ADDENDUM NO. 1

Project Name: Chamber of Commerce Renovation and Addendum

ADDENDUM B

DATE	March 12, 2021		
PROJECT	Dublin Chamber of Commerce Renovation	PROJECT NO.	19305
OWNER	City of Dublin	SENT VIA	Email

AS-001

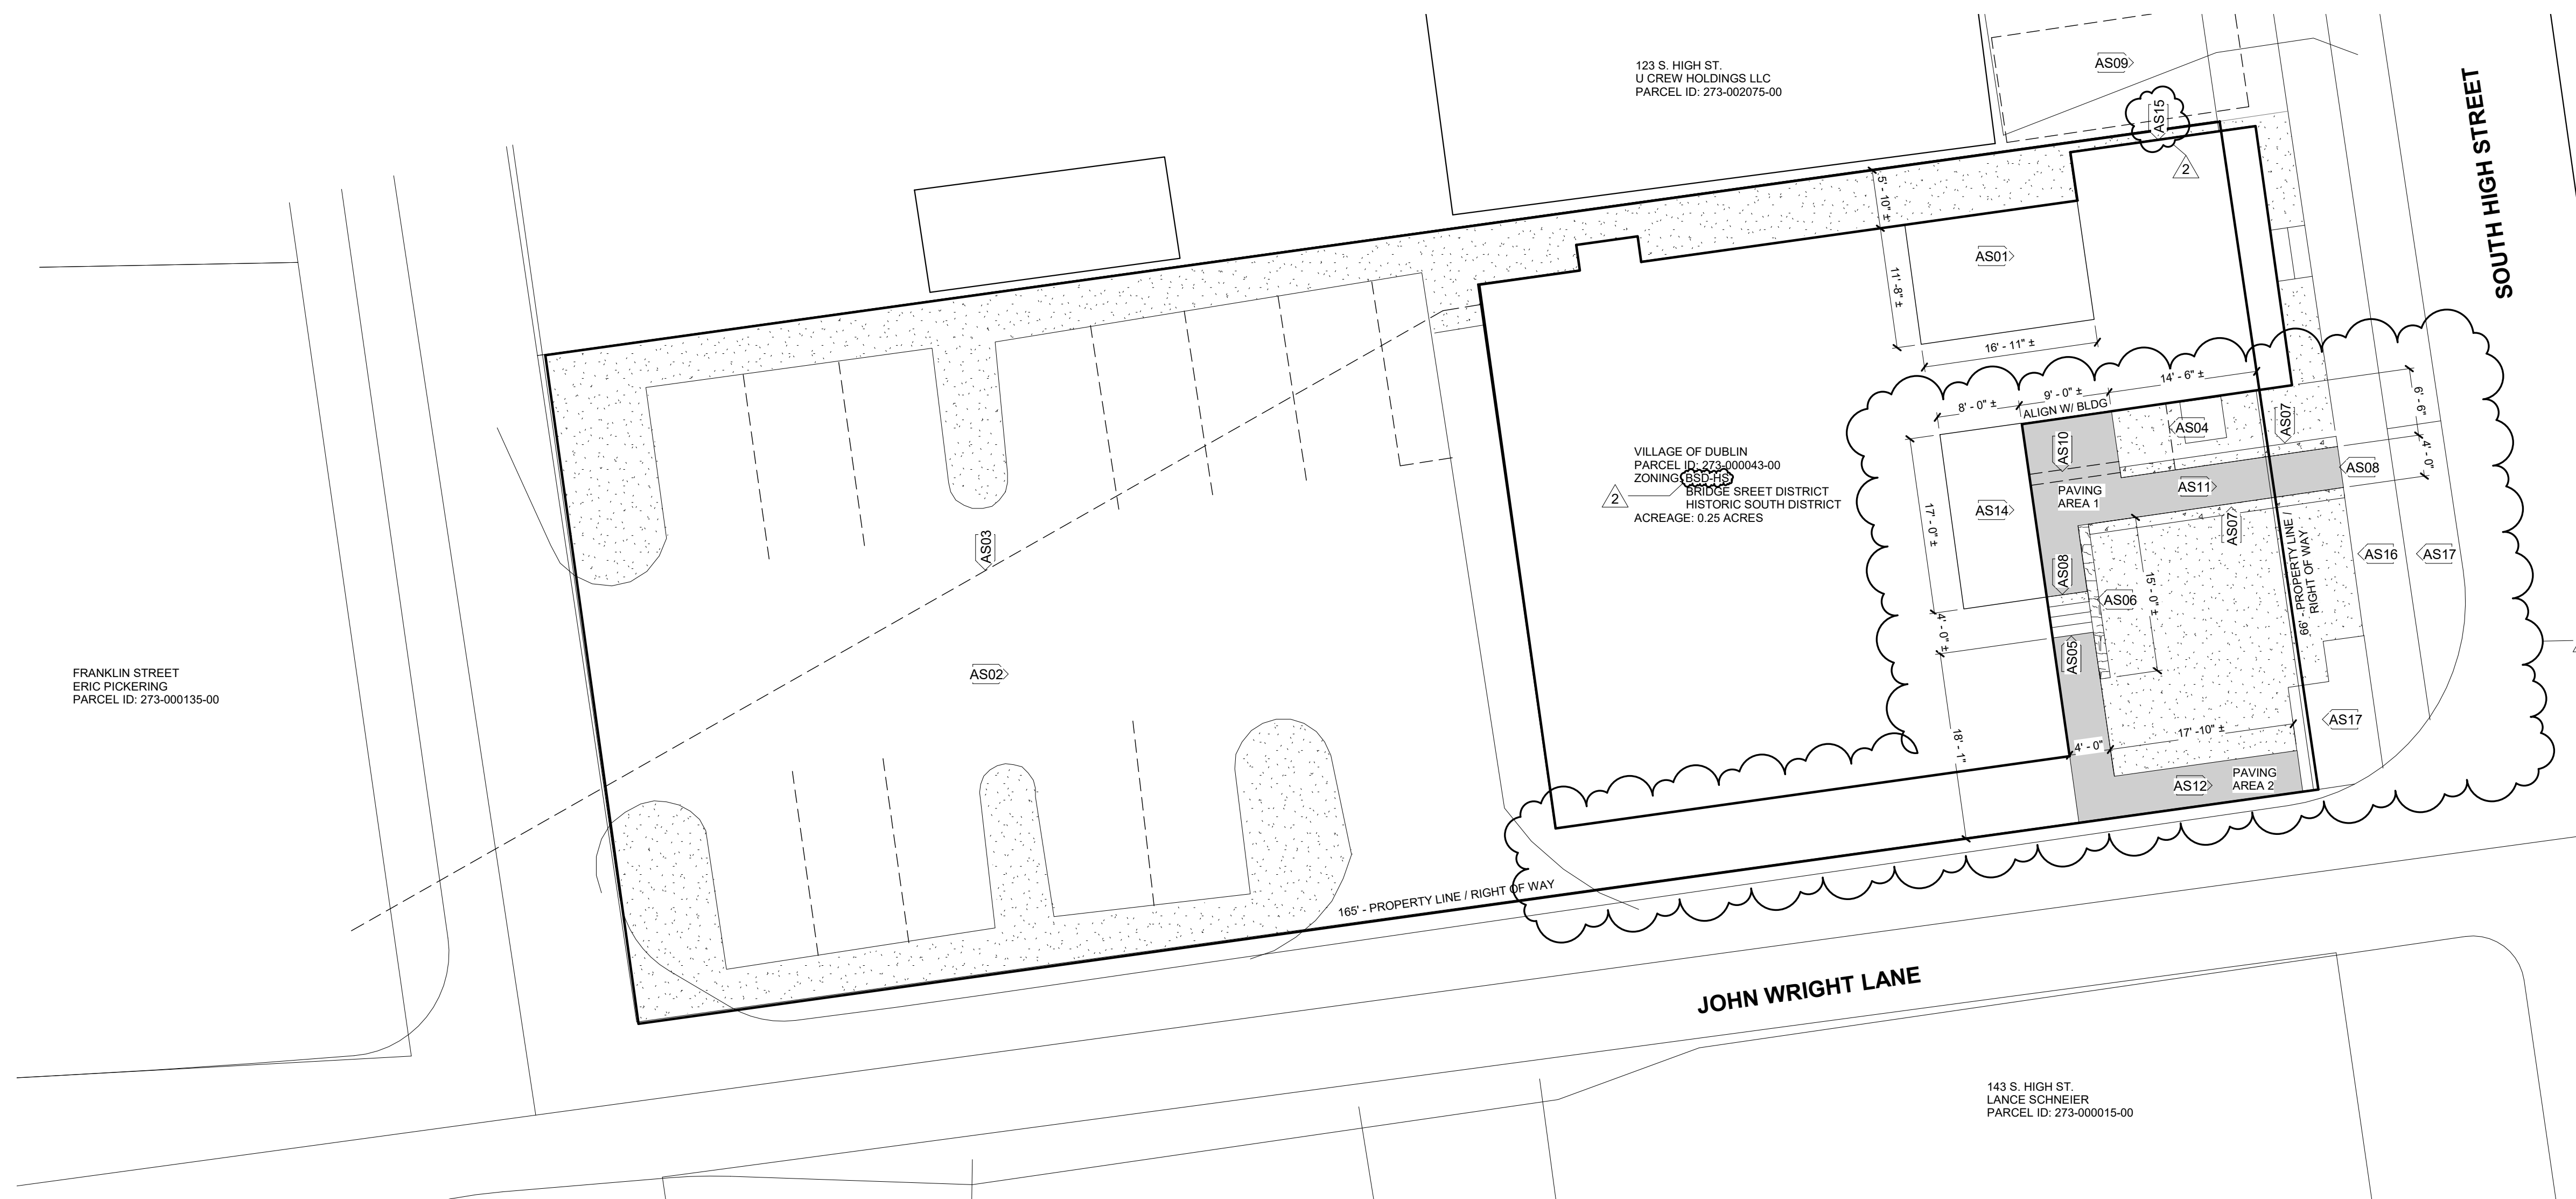
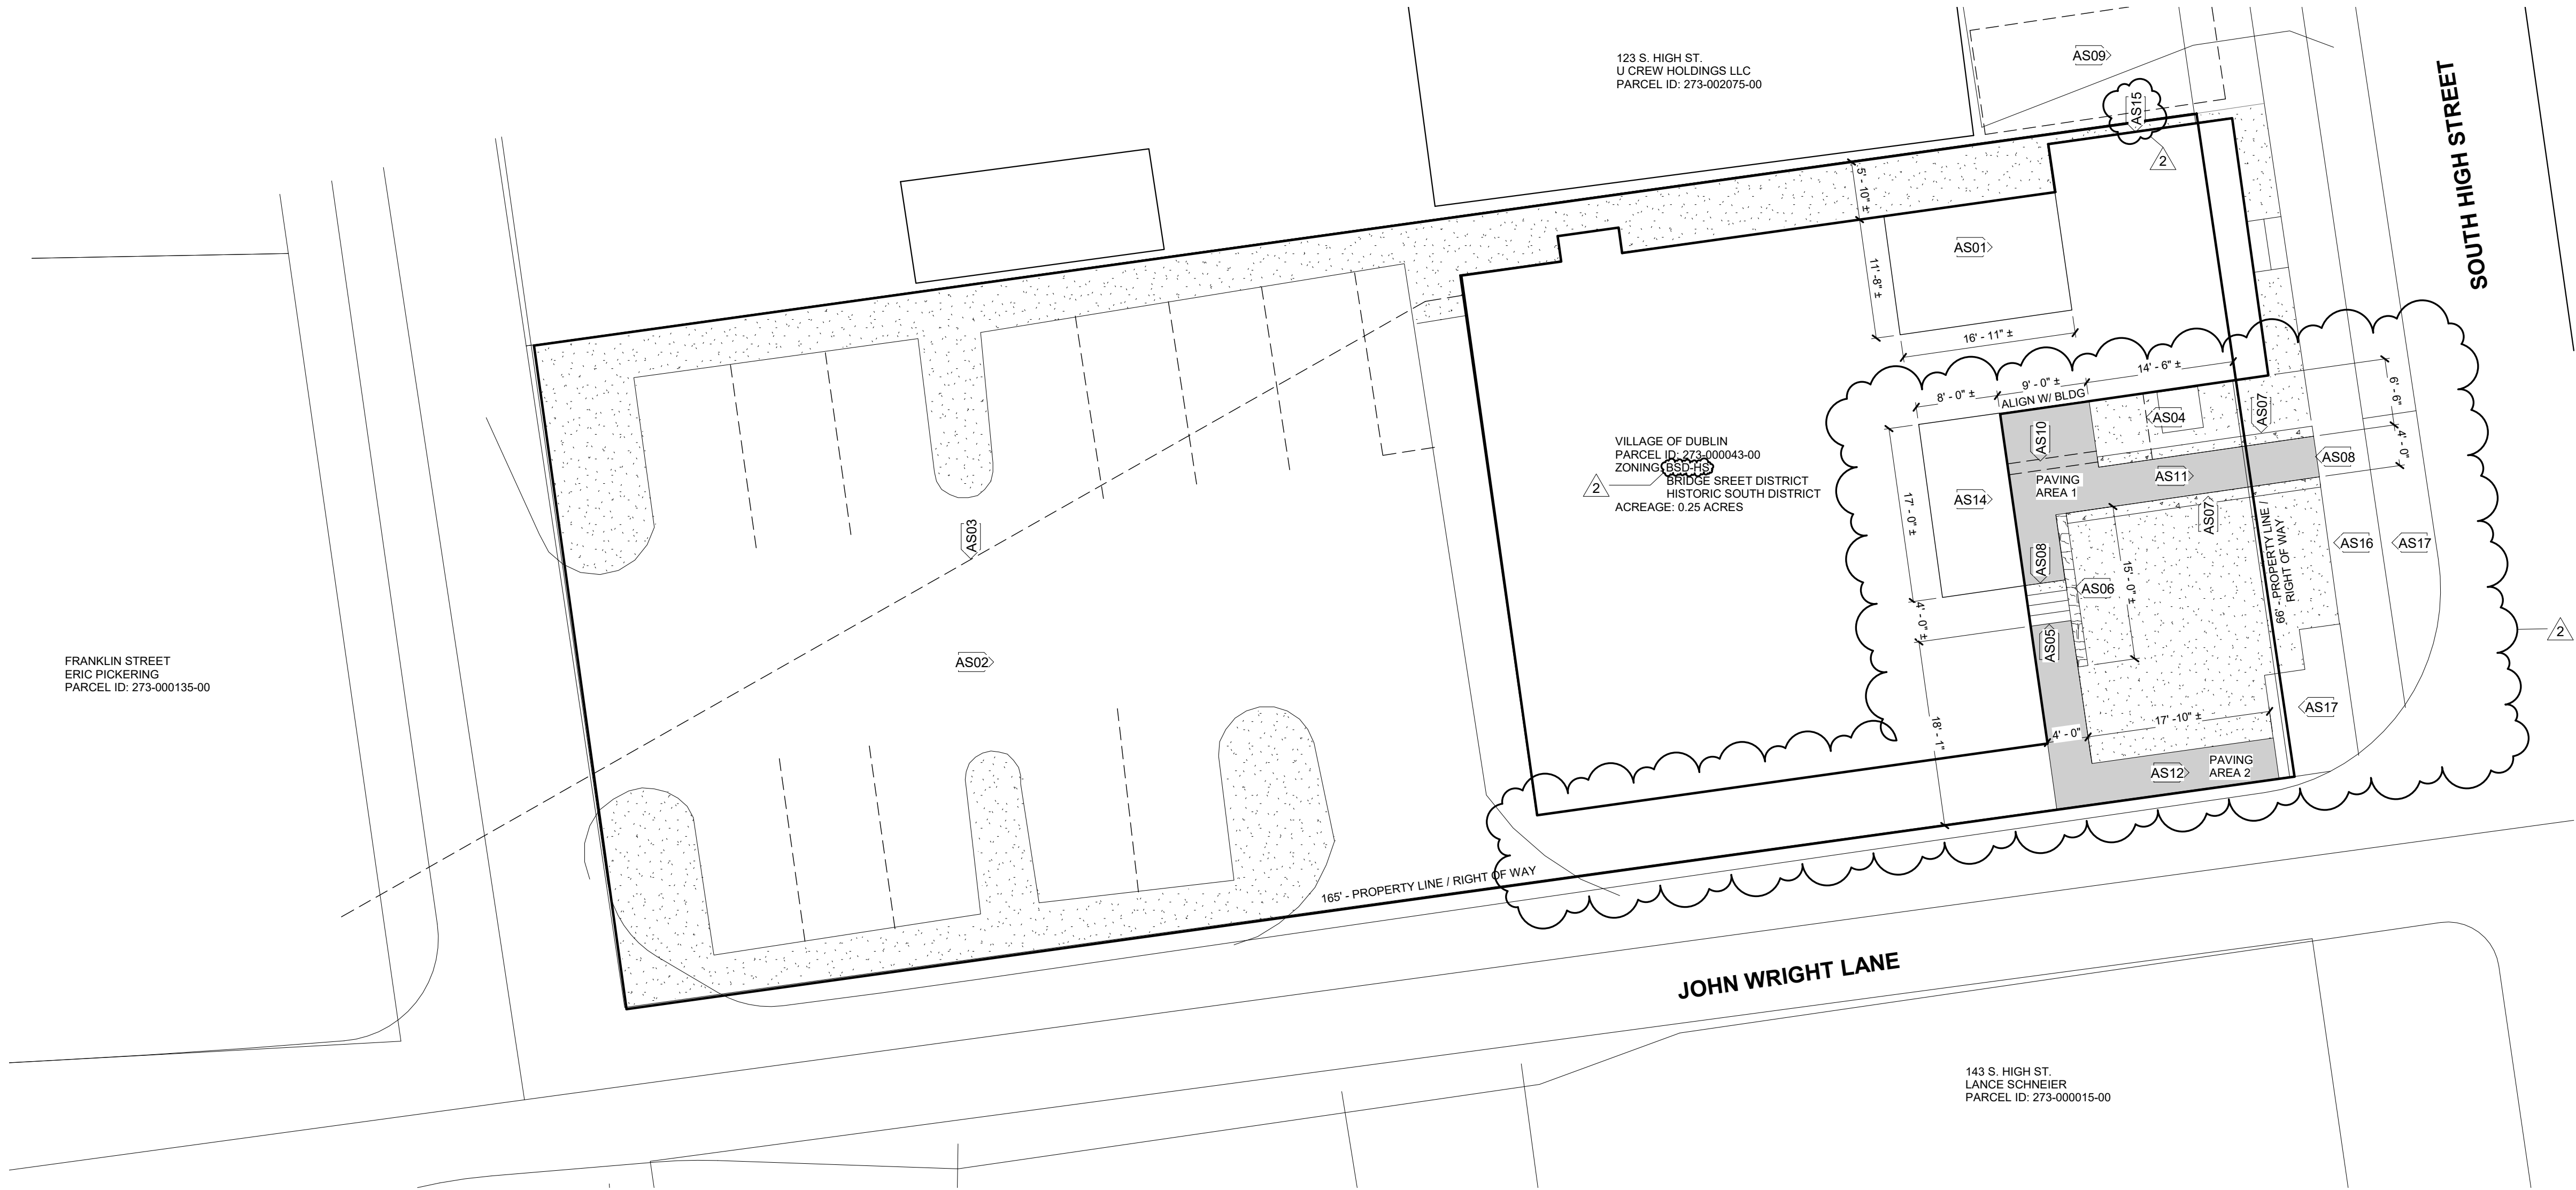
SHEET	ITEM	DESCRIPTION
P		
G-001	01	Revise sheet index to reflect Addendum revisions.
	02	Clarify tenant information.
	03	Add architectural stamp.
AS-001	01	Remove bid alternate #1 (coded note AS03) from scope of project.
	02	Remove permeable pavers at street from scope of project.
	03	Revise typo at Zoning district.
	04	Add dimensions of permeable pavers for clarity.
	05	Revise square footages of permeable pavers to reflect revised layout.
	06	Add coded notes AS15, A16, and A17.
	07	Revise brick paver specification.
	08	Add paver detail for clarity.
A-601	01	Change specification for WT-1 and WT-2 on finish legend.
	02	Add grout color to WT-3 specification on finish legend.
	03	Add CAB-1 specification on finish legend.
	04	Note PL-1 as not used on finish legend.
	05	Change cabinet type in rooms 107 & 114.
A-701	01	Revise elevations F & G.

1. REMOVE EXISTING SURFACES:
A. PAVING AREAS 1 AND 2. REMOVE EXISTING PAVEMENT AND/OR CONCRETE WALKWAY IN AREA OF WORK.
B. PAVING AREA 3. REMOVE FROM SCOPE OF WORK.

2. EXCAVATE TO FIRM SOIL. MINIMUM DEPTH OF 18 INCHES.

3. COVER THE EXCAVATION WITH A 6-INCH LAYER OF 3/4 WASHED CRUSHED STONE. COMPACT TWICE WITH A PLATE COMPACTOR. ACROSS AND LENGTHWISE.
